Appl. No. 10/724,570  
Amdt. Dated July 20, 2006  
Reply to Office Action of July 20, 2006

**Amendments to the Drawings:**

FIG. 8 PRIOR ART

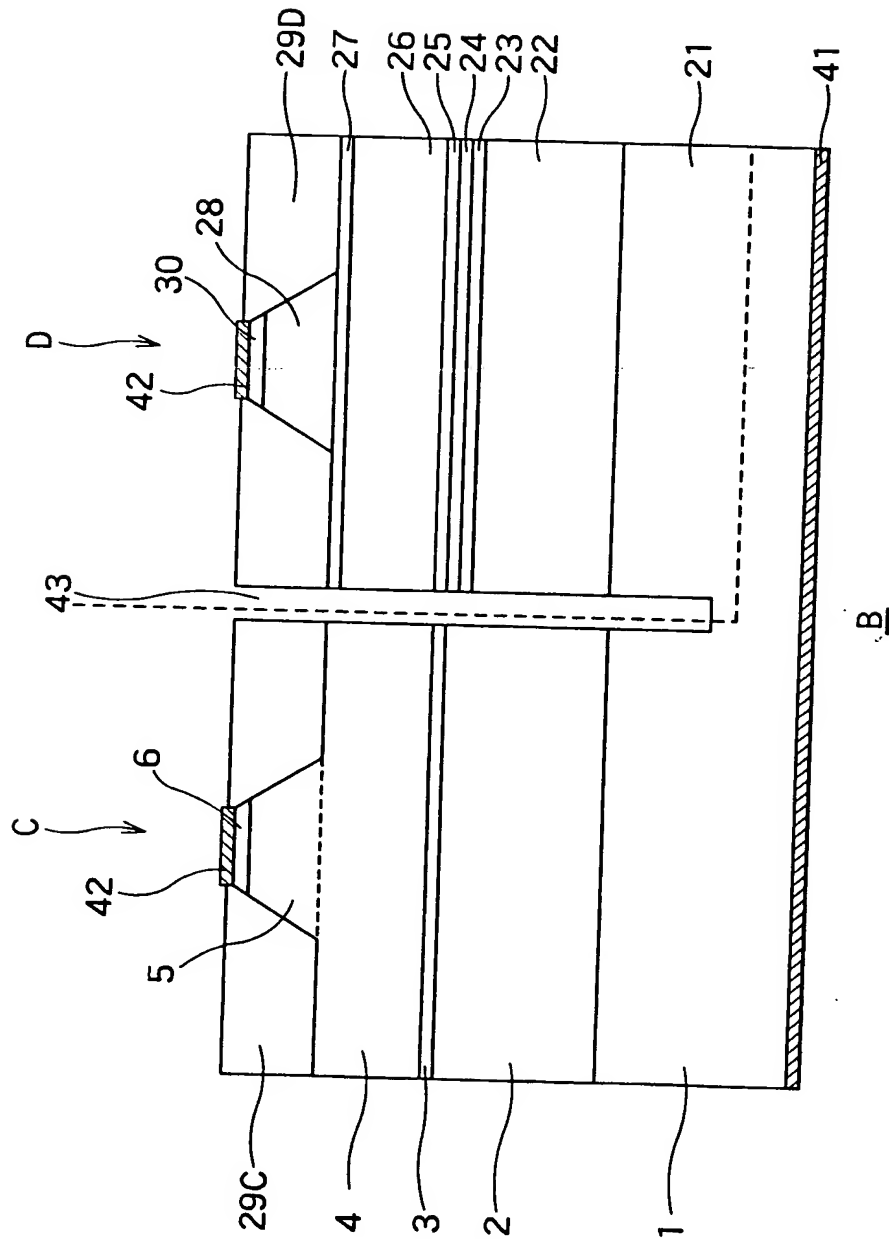
The attached sheet of drawings includes changes to FIG. 8. This sheet, which includes FIG. 8, replaces the original sheet including FIG. 8. Applicant adds the label "Prior Art" to FIG. 8.
